Informal document No. **GRB-43-1**
(43th GRB, 21-23 February 2006
agenda item 1.5.1.)

World Forum for Harmonization of Vehicle Regulations (WP.29)

PROPOSAL FOR DRAFT AMENDMENTS TO REGULATION No. 117

(Tyre rolling sound)

Example 1

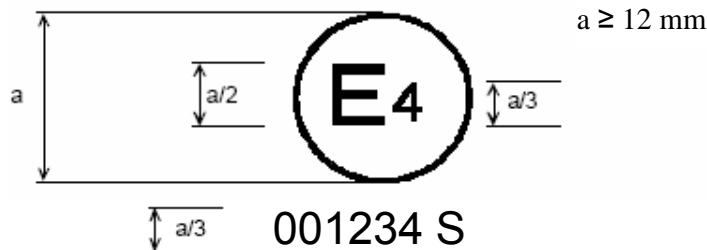
The above approval mark, affixed to a pneumatic tyre shows that a tyre concerned has been approved in the Netherlands (E4) pursuant to Regulation No. 117 (marked by S (rolling sound only), under approval number 001234. The first two digits of the approval number (00) indicate that the approval was granted according to the requirements of this Regulation in its original form.

Example 2

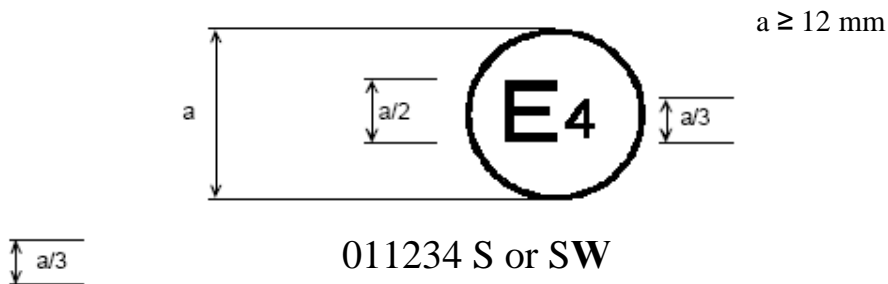
The above approval mark shows that the tyre concerned has been approved in the Netherlands (E4) pursuant to Regulation No. 117 (marked by S (rolling sound) **or both S (rolling sound) and W (wet adhesion)**, under approval number **011234**. This indicates that the approval is for **S or both SW**. The first two digits of the approval number (**01**) indicate that the approval was granted according to the **01** series of amendments.

Example 1

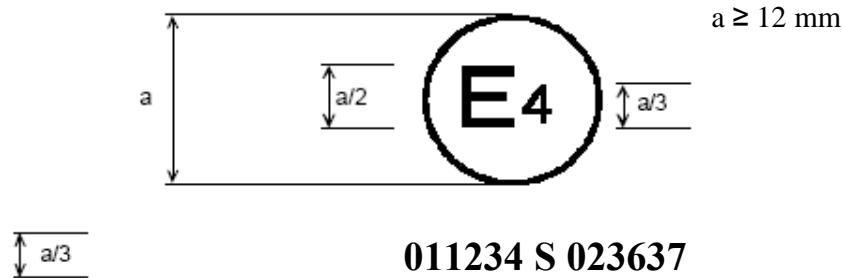
The above approval mark shows that the tyre concerned has been approved in the Netherlands (E4) pursuant to Regulation No. 117 (marked by S (rolling sound), under approval number 011234 and Regulation No. 30 under approval number 023637. The first two digits of the approval number (01) indicate that the approval was granted according to the 01 series of amendments, but Regulation No. 30 included the 02 series of amendments.

Example 2

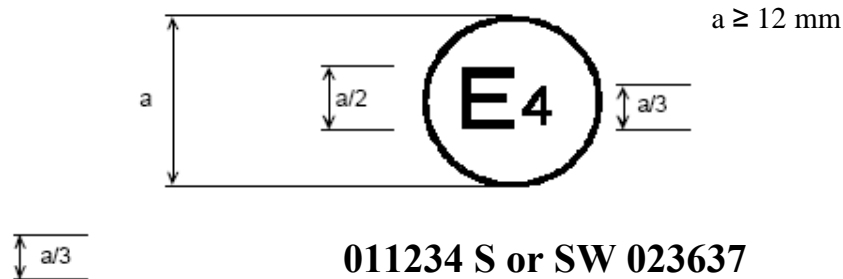
The above approval mark shows that the tyre concerned has been approved in the Netherlands (E4) pursuant to Regulation No. 117 (marked by S (rolling sound) or SW (rolling sound and wet adhesion), under approval number 011234 and Regulation No. 30 under approval number 023637. The first two digits of the approval number (01) indicate that the approval was granted according to the 01 series of amendments, but Regulation No. 30 included the 02 series of amendments.

Example 3

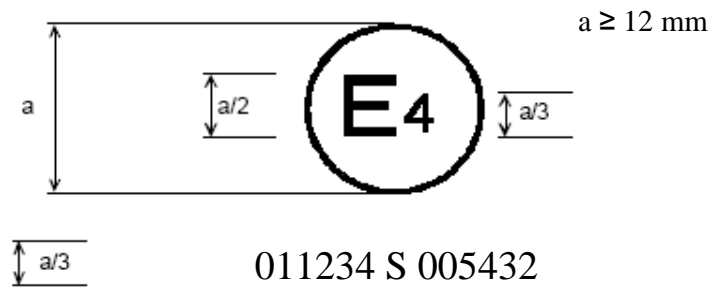
The above approval mark shows that the tyre concerned has been approved in the Netherlands (E4) pursuant to Regulation No. 117 and the 01 series of amendments under approval number 011234 (marked by S only), and Regulation No. 54. This indicates that the approval is for rolling sound (S) only, as Regulation No. 54 approved tyres at present cannot be approved for wet adhesion. The first two digits of the Regulation No. 117 approval number (01) in conjunction with 'S' indicate that the first approval was granted in accordance with Regulation No. 117 which included the 01 series of amendments. The first two digits of Regulation No. 54 (00) indicates that this Regulation was in its original form.

Example 1

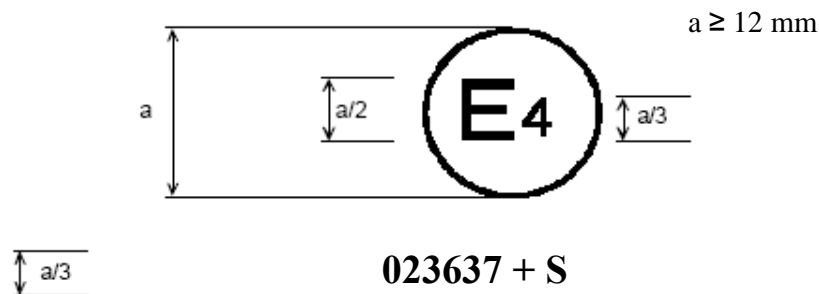
The above approval mark shows that the tyre concerned has been initially approved in the Netherlands (E4) pursuant to Regulation No. 30 and the 02 series of amendments under approval number 023637. It is also marked by + S (rolling sound) which indicates that its approval is extended under Regulation No. 117. The first two digits of the approval number (02) indicate that the approval was granted according to Regulation No. 30 which included the 02 series of amendments. The addition (+) sign indicates that the first approval was granted in accordance with Regulation No. 30 and has been extended to include Regulation No. 117 approval(s).

Example 2

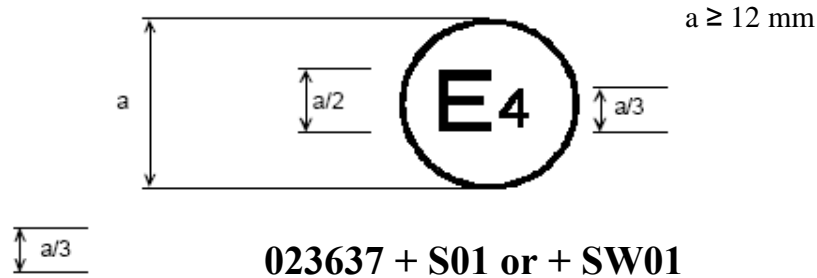
The above approval mark shows that the tyre concerned has been initially approved in the Netherlands (E4) pursuant to Regulation No. 30 and the 02 series of amendments under approval number 023637. This indicates that the approval is for S (rolling sound) or S (rolling sound) and W (wet adhesion). The S or SW followed by (01) indicates that it has had its approval extended under Regulation No. 117 which included the 01 series of amendments. The first two digits of the approval number (02) indicate that the approval was granted according to Regulation No. 30 which included the 02 series of amendments. The addition (+) sign indicates that the first approval was granted in accordance with Regulation No. 30 and has been extended to include Regulation No. 117 approval(s)."
